## Chapter 3

# Revisions to the Draft EIR

Figure 2-3  
Proposed Conceptual Site Plan

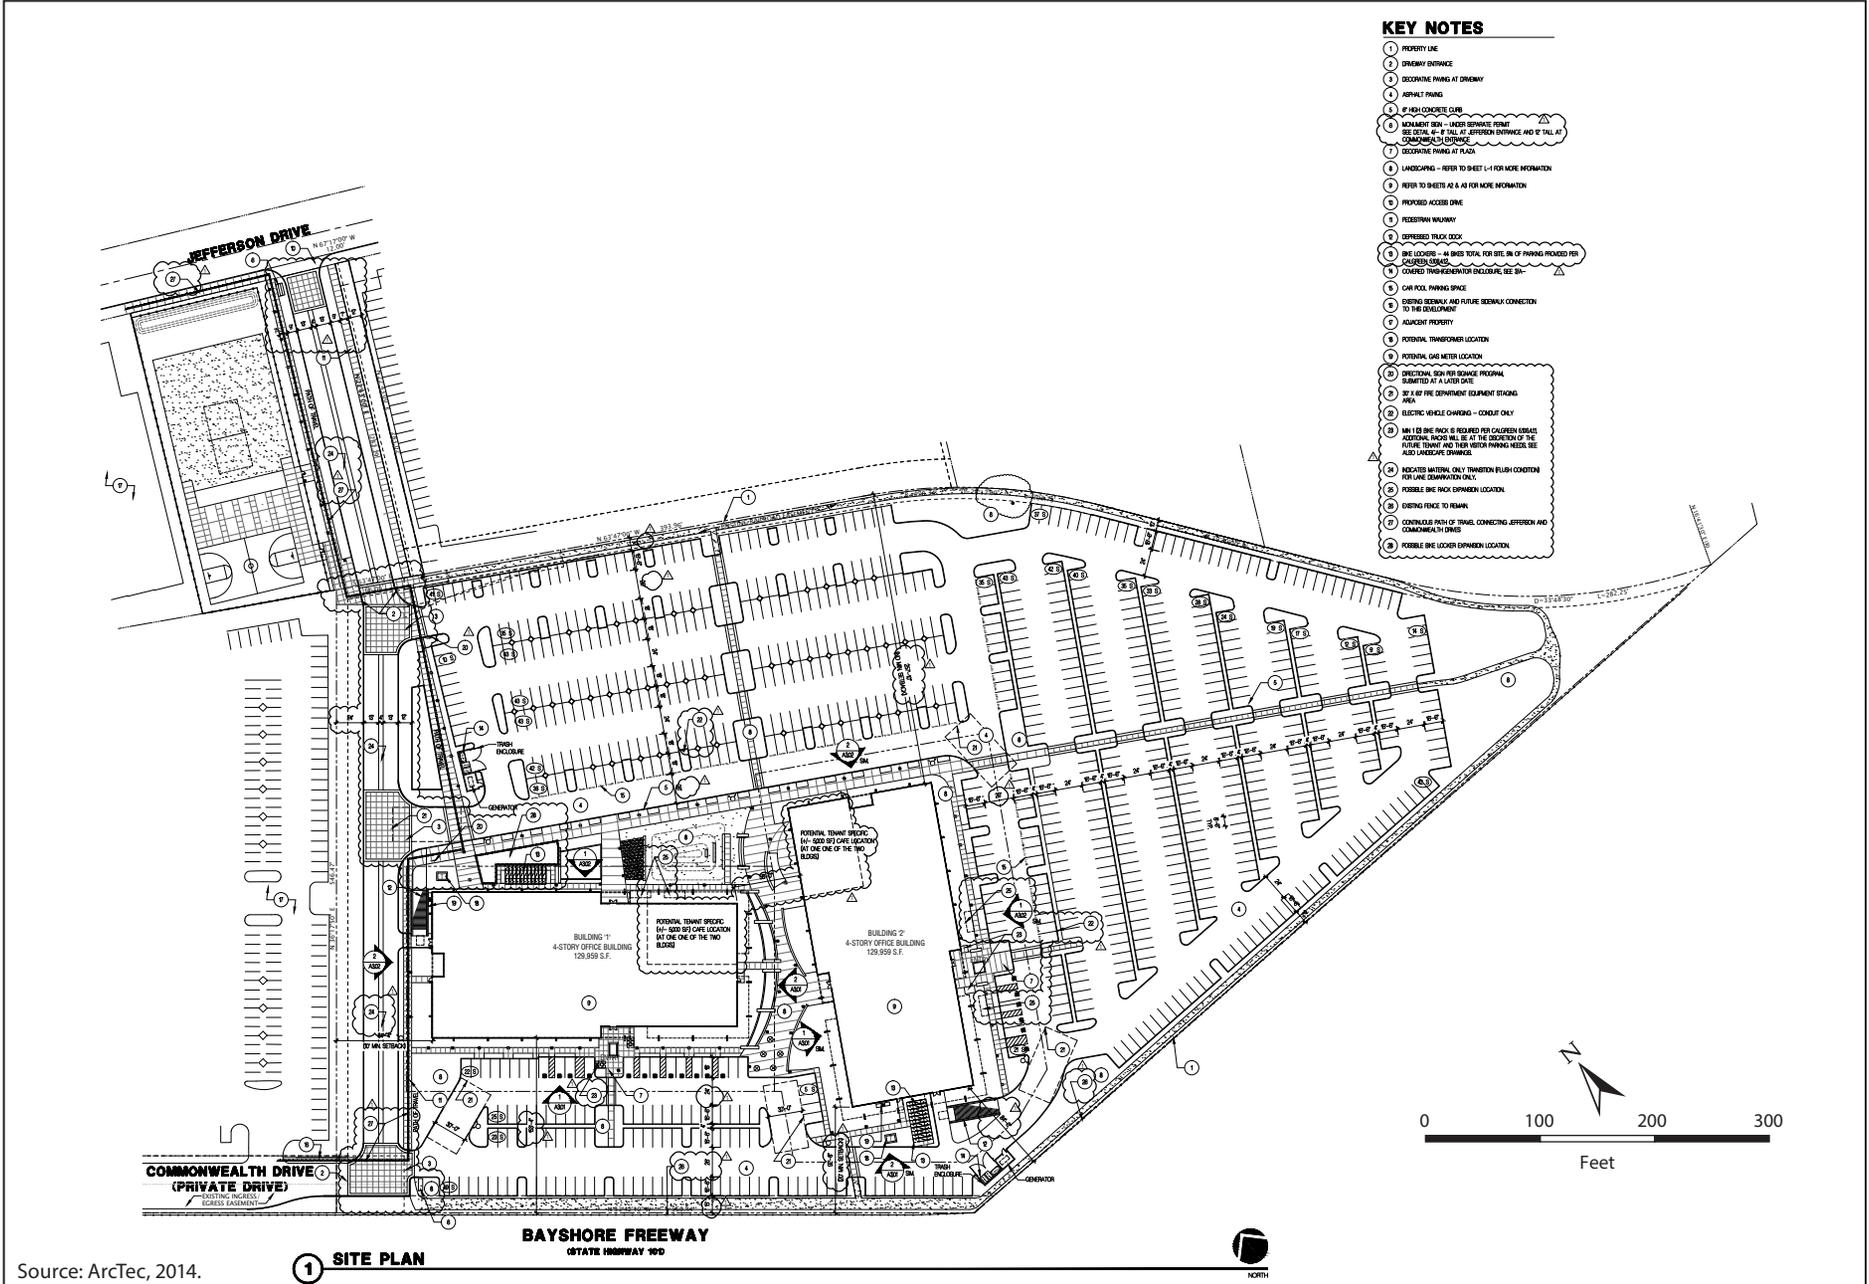
Figure 2-3, “Proposed Conceptual Site Plan,” following page 2-4 of the Draft EIR, has been revised to add trails and enhance the connection between Commonwealth Drive and Jefferson Drive. This updated figure is included on the following page. The revisions relate to the site design and do not change the fundamental descriptions of the Project or analysis presented in the Draft EIR. Therefore, no additional revisions related to the updated site plan are provided in this chapter.
